PROJECT: Request for Proposals - Equipment
BID DATE/TIME: July 31, 2024, at 2:00 pm Central Time
OWNER: Town of Tracy City
DATE: July 29, 2024
ITEMS INCLUDED: Addendum (2 pages)

CLARIFICATION:

Reaction Tank

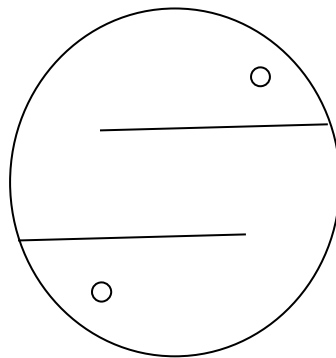
- Tank shall have an embedded starter ring with a concrete floor. No Steel floor is required. Inlet, outlet and drain piping shall be embedded in the floor and stubbed a distance of 10' beyond the foundation limit. All Buried piping shall be pressure class 350 ductile iron with restrained fittings.
- No geotechnical report is available for this site. If required, a geotechnical survey of the site at the location of the proposed tank will be provided to the selected manufacturer prior to final design.
- Baffle walls shall be provided for the project. Baffles shall be constructed of ½" polyethylene panels securely attached to the walls/ roof in order to provide a rigid divider. The tank baffling system shall divide the tank into approximately 3 section and be generally as shown below:
